UNITED STATES PATENT AND TRADEMARK OFFICE

Office Action Summary

10/714,191

DETAILED ACTION

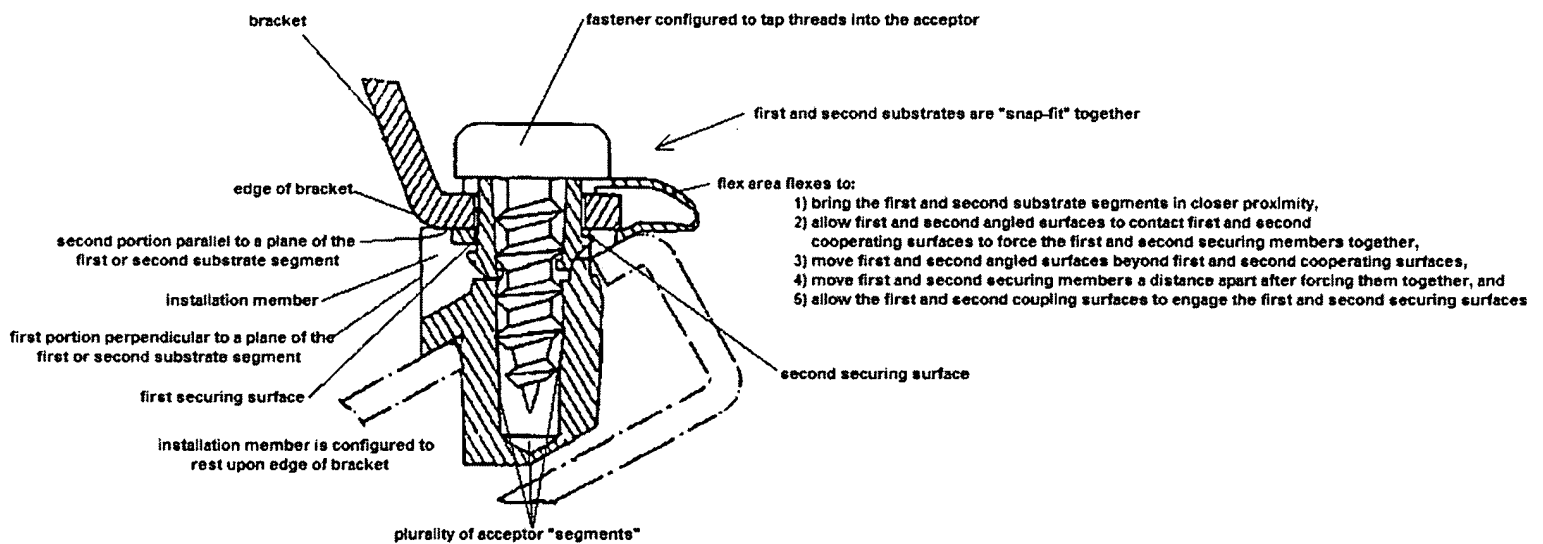
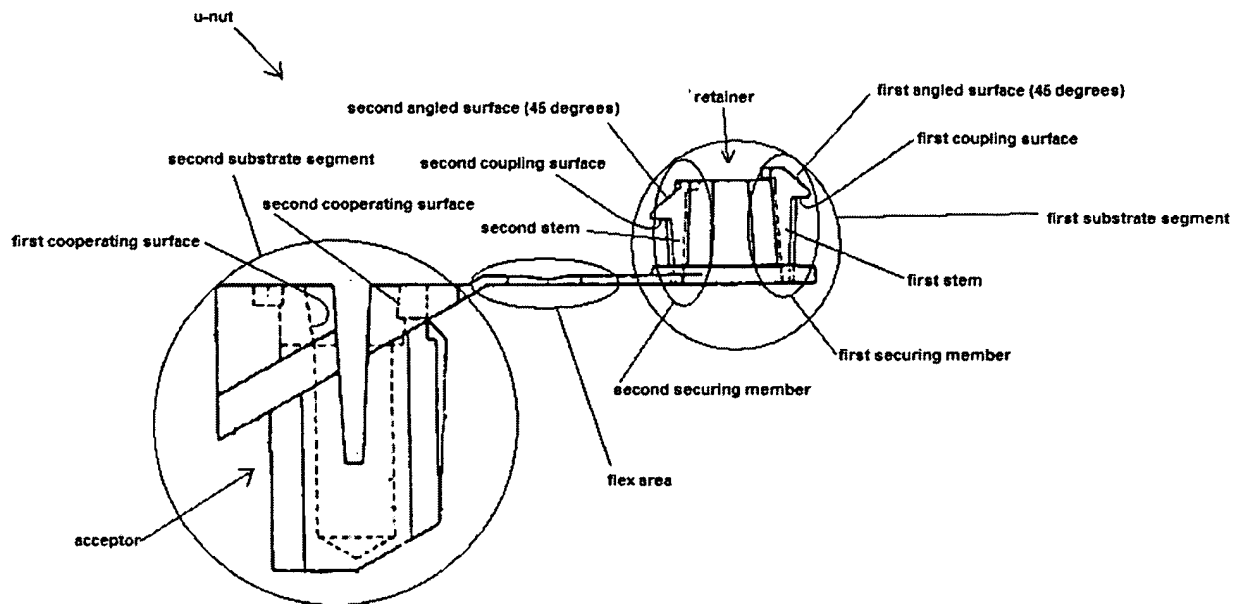
[7] Claims 1-20 are rejected under 35 U.S.C. 102(b) as being anticipated by Vasseur et al. US-5,779,411.

In short, Vasseur et al. teach a U-nut (1) having a flex area (3), first substrate segment (2), and second substrate segment (4). The first substrate segment has a retainer comprising a first securing member (22) and second securing member (24) -- each having a stem (22,24), angled 45° surface (26,27), and coupling surface (28,29). The second substrate segment (4) has an acceptor (16) having first and second cooperating surfaces (8,11) and first and second securing surfaces (16). The first and second securing members are snap fit within the acceptor (abstract lines 1-2). The U-nut may comprise a fastener (15) configured to "tap threads into the acceptor" (col. 3 lines 35-38) so as to provide a clamping force. The U-nut has what could broadly be construed as an "installation member" (7,10,13) that is "configured to" (i.e., capable of) "resting upon an edge of a bracket (40,50). Note that any portions of the acceptor could be broadly construed as "a plurality of acceptor segments".
